ADDENDUM NO. 03

PROJECT: Suffern Central School District
RP Connor Heating System Conversion

CPL PROJECT NO. 12396.23

DATE: 7/13/2023

3
H701
BOILER ROOM NEW WORK GAS, BREECHING, AND COMBUSTION AIR PLAN PHASE 2
SCALE: 1/4" = 1'-0"

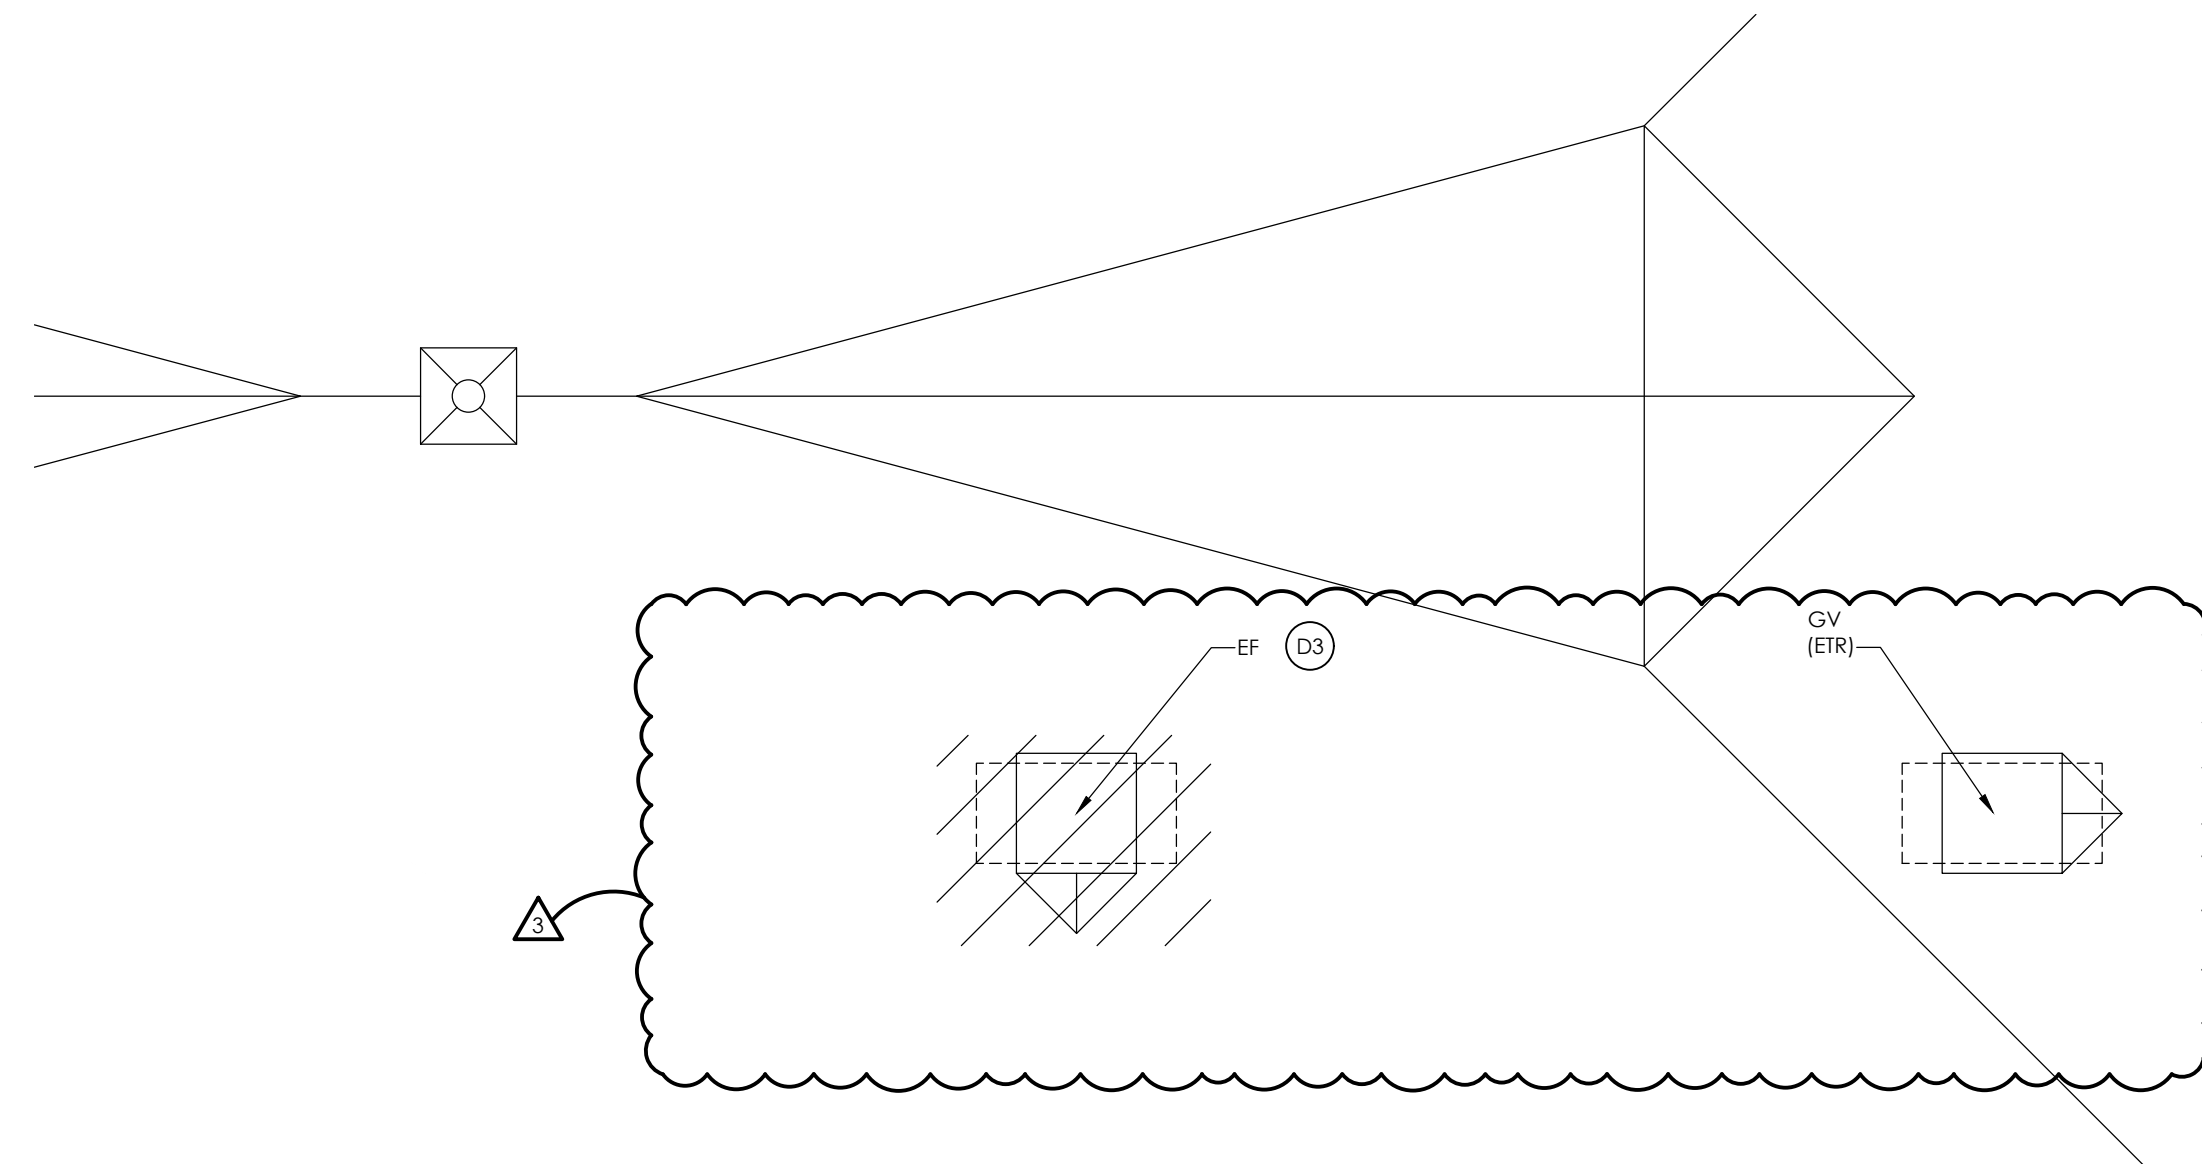
- 2.1 Replace drawing H201A with revised H201A drawing attached.
- 2.2 Replace drawing H201C with revised H201C drawing attached.
- 2.3 Replace drawing H700 with revised H700 drawing attached.
- 2.4 Replace drawing H701 with revised H701 drawing attached.
